Southern Nuclear Operating Company Vogtle Electric Generating Plant, Units 3 & 4 COL Application

COL Application

Part 5

Emergency Plan

Figure ii Vogtle Electric Generating Plant Site Plan

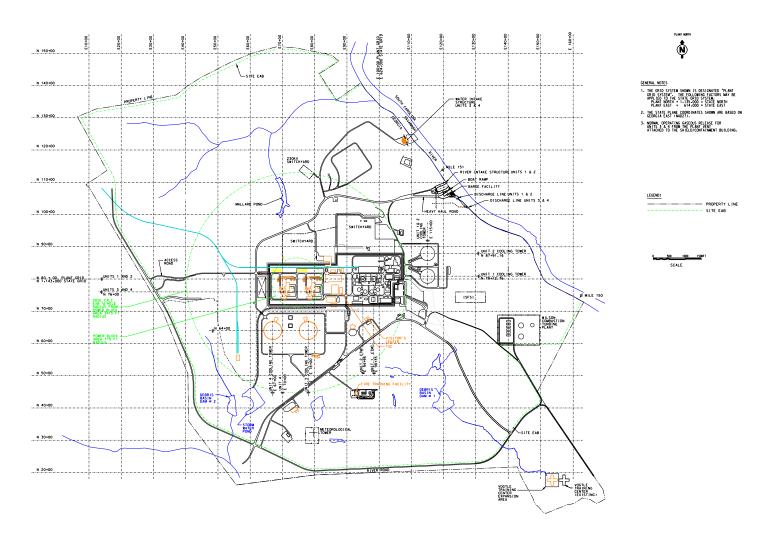
Replace Preface page xiii, Figure ii, Vogtle Electric Generating Plant Site Plan, with the attached Preface Figure ii.
